New Parameter Values for Micro-Reflection Limits

Contribution to IEEE 802.3cy

December 21, 2021

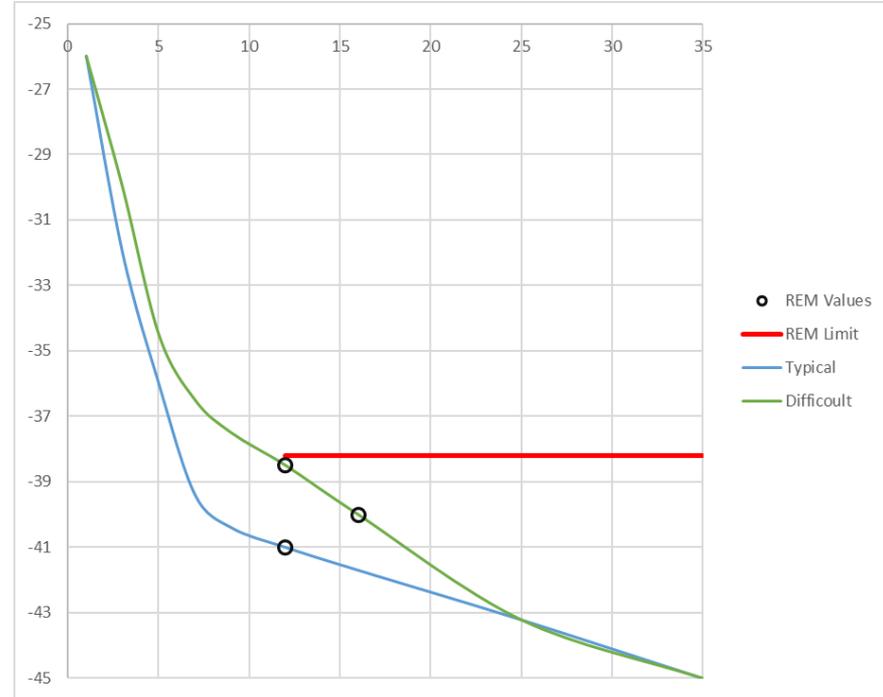
- f_c is **4GHz**,
- REM_{max} is **-30dB** and
- REM_{offset} is **20dB**

Only the $N_{discard}$ value has changed from the proposal in

- Previously proposed value of $N_{\text{discard}}=12$ was based on REM calculations for simulated and measured cables
- We have done a detailed review of larger set of cable measurements
- In some cases, the echo response from the connectors might spread out over more bins than what had previously been observed
- Using $N_{\text{discard}}=16$ provides extra REM margin for the more challenging cable assembly
